Copier Bulletin: TSB-1078

Models: e-STUDIO1355 Series

Subject: Service Manual Correction – Tray Heaters

Connecting the Tray Heaters of the Main Machine

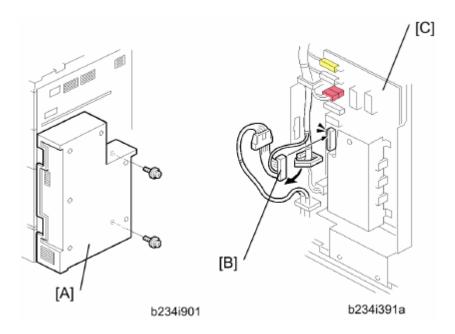
The machine comes from the factory **without** the tray heaters **already** installed **but disconnected**. Tray heater **installation** is optional. The heaters should be connected if the location has high humidity.

Doing this procedure connects the **following** anti-condensation heaters inside the main machine at the following locations:

- One unit below the transfer unit (if installed)
- Two units in the paper tray unit (if installed)
- One unit in the scanner unit (if installed)
- One unit in the LCIT (if installed)

- 1. Switch off the main power switch and disconnect the power cord from the power source.
- 2. Open the PSU box [A].

To set the connector

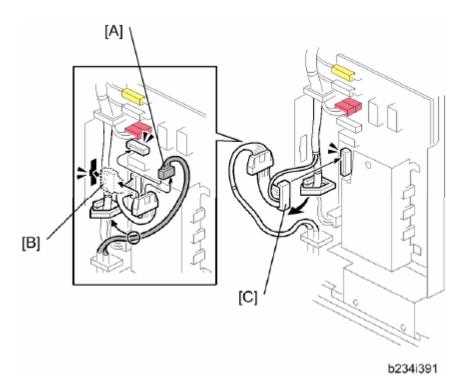
1. Connect the white connector [B] to CN602 on the AC drive board [C].

- Connect the large connector clamped beneath the board.
- This step is not required if the LCIT anti-condensation heater will be connected.
